Subject: **Bid No. 8819-M7 – Sprinkler & Fire Alarm Modifications – Union Station / WRA**

ADDENDUM NO. 3

SPRINKLER AND FIRE ALARM
MODIFICATIONS PHASE 2
UNION STATION
WORCESTER, MA

2 PARTIAL ELECTRICAL POWER PARTIAL FIRST FLOOR NEW WORK PLAN
3/32"=1'-0"

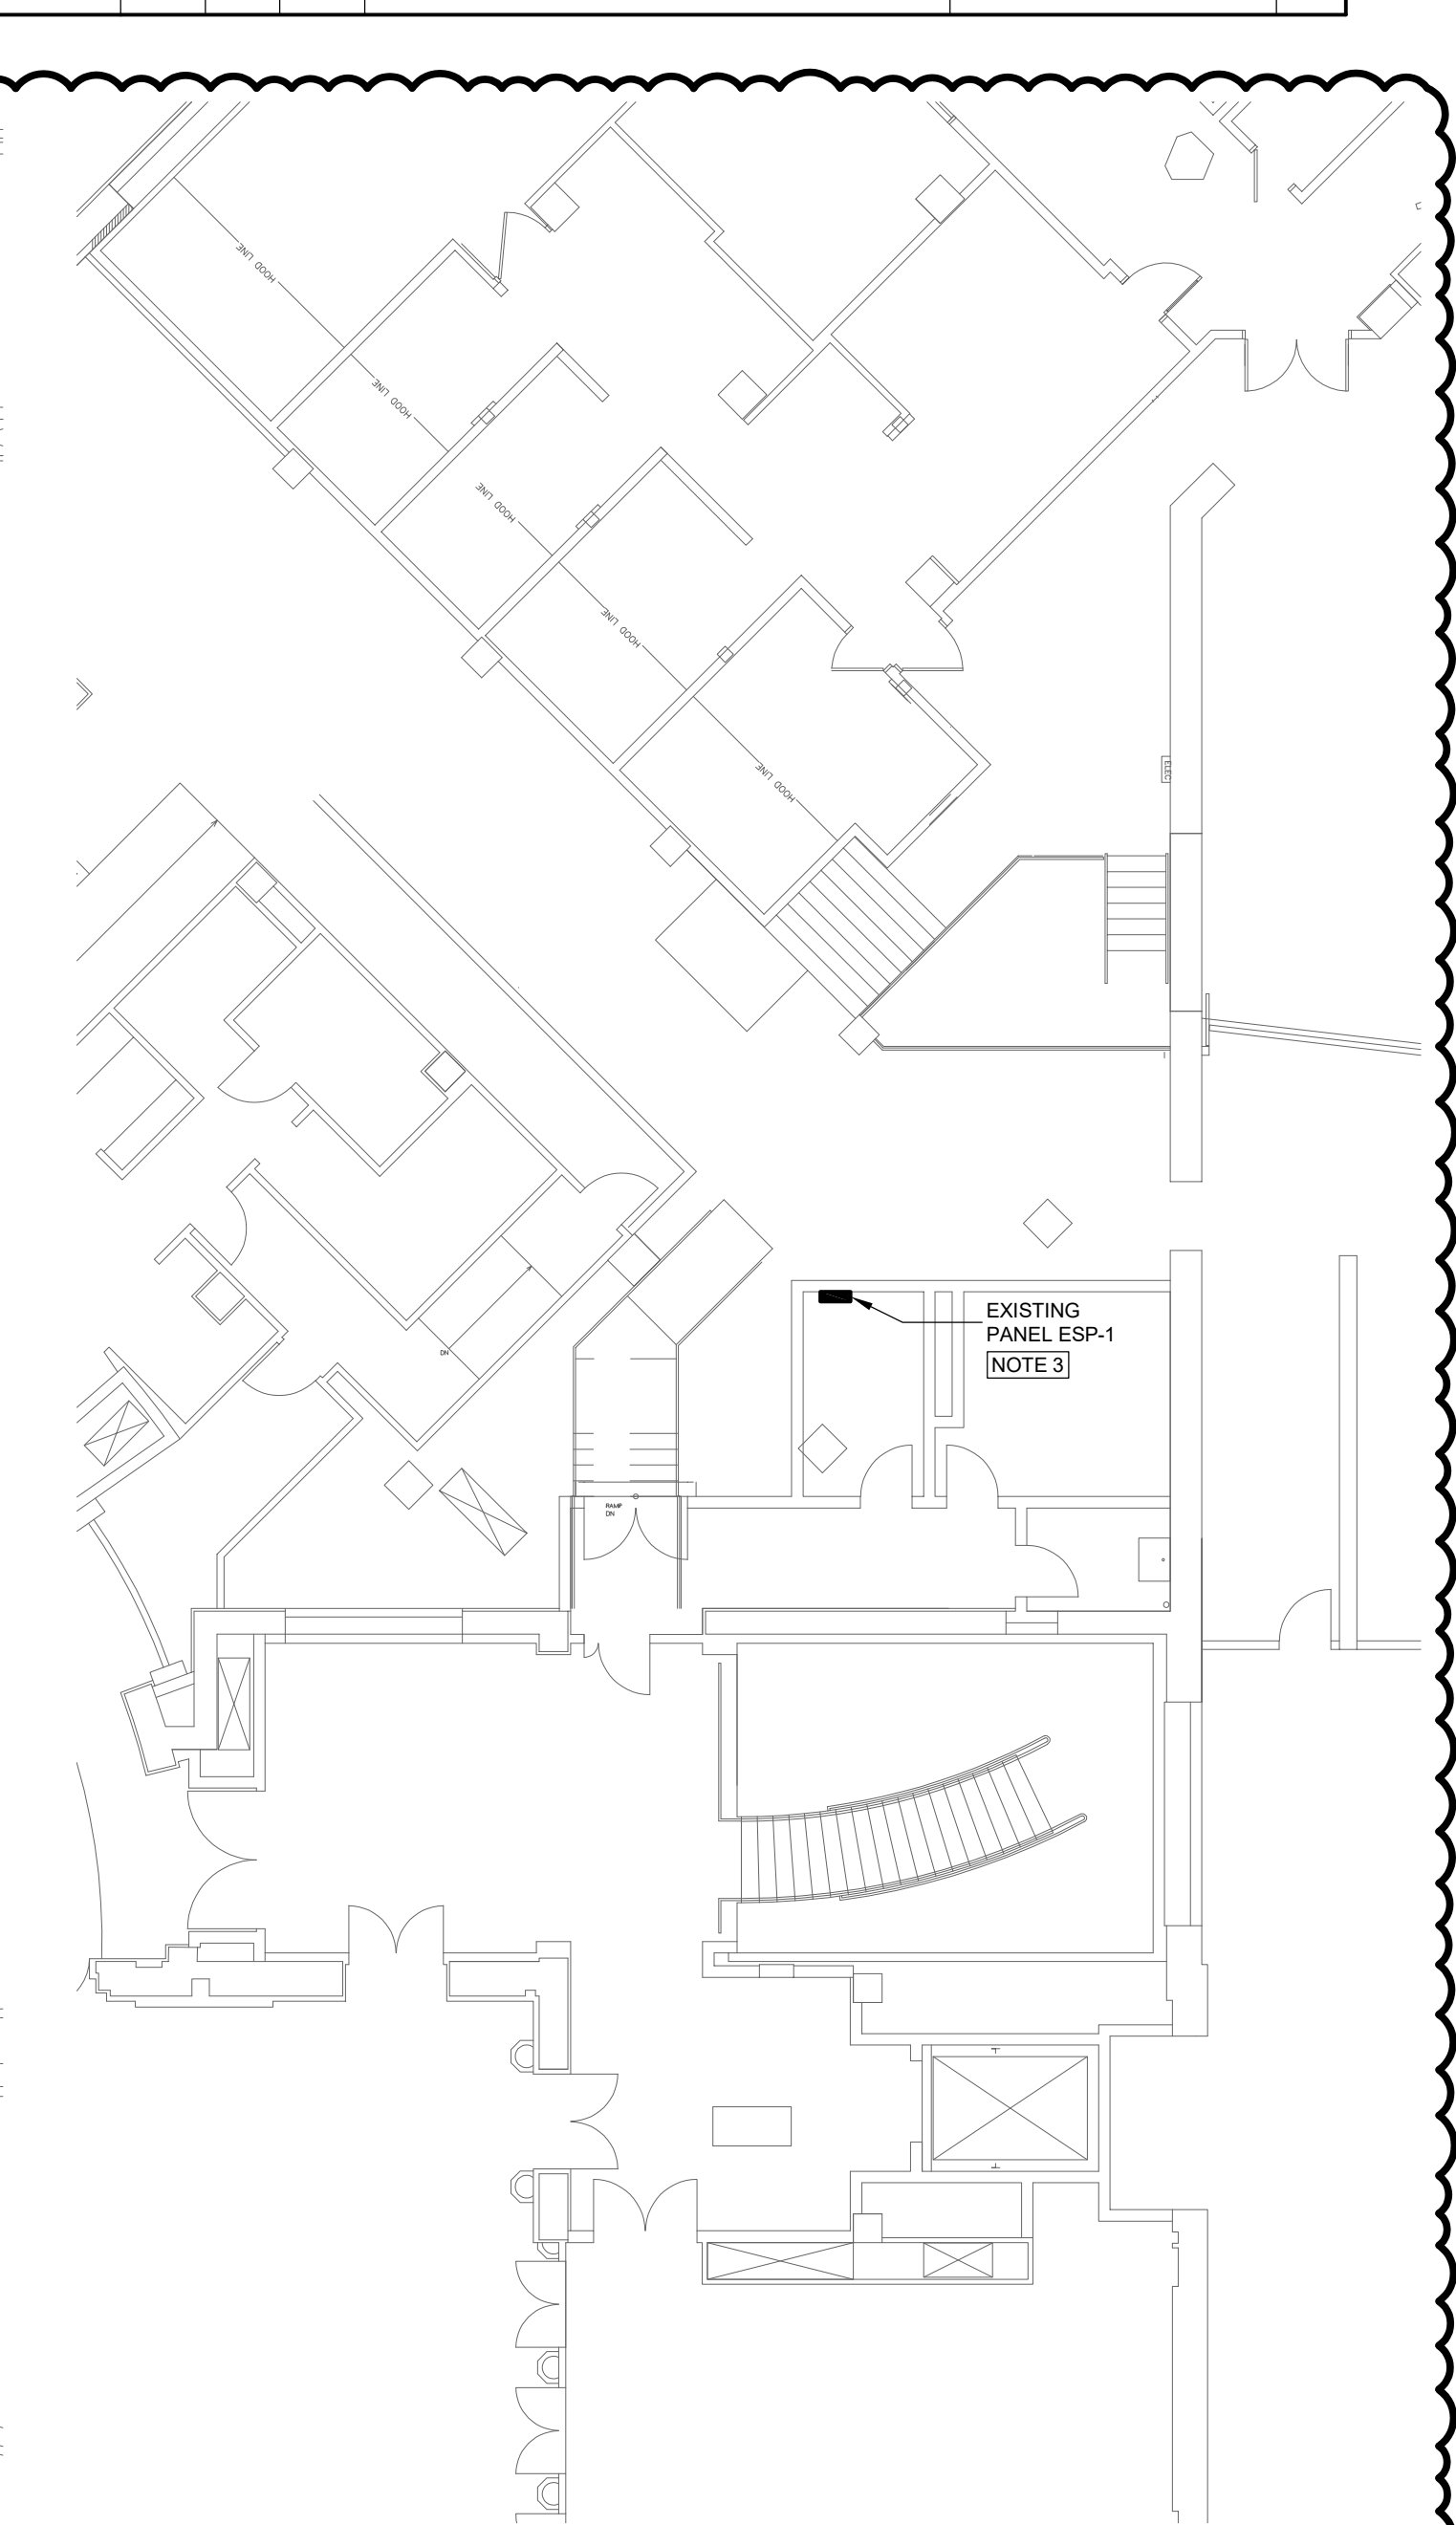
Drawing E101, Electrical Power Partial First Floor New Work Plan, Revise as follows:

- ADD power supply circuit for fire alarm remote command center.
- ADD panel schedule for existing Panel ESP-1.

FA001

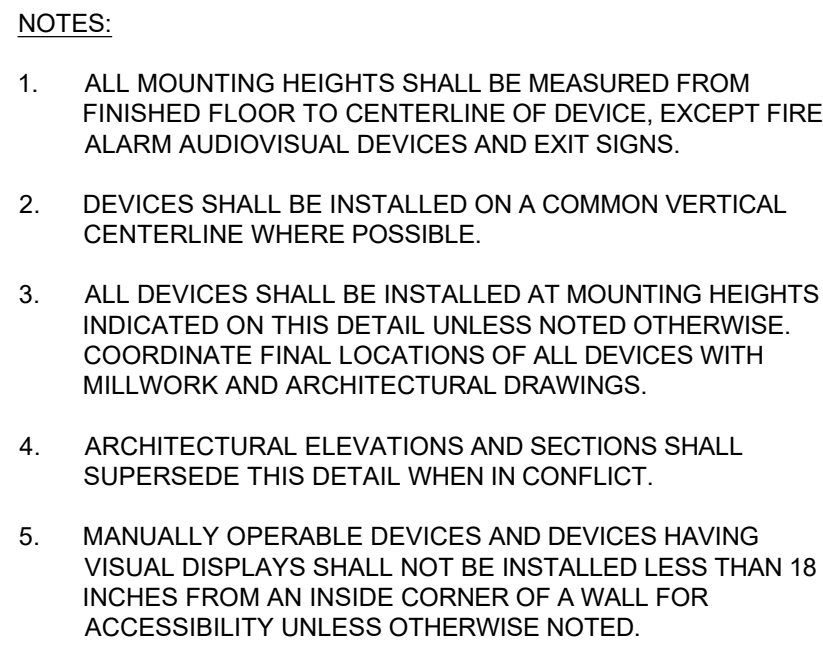
Drawing FA001, Fire Alarm Legend and Notes, Revise as follows:

- ADD symbols to Legend for Beam Detector Transmitter/Receiver and Reflecting Mirror for Beam Detectors.
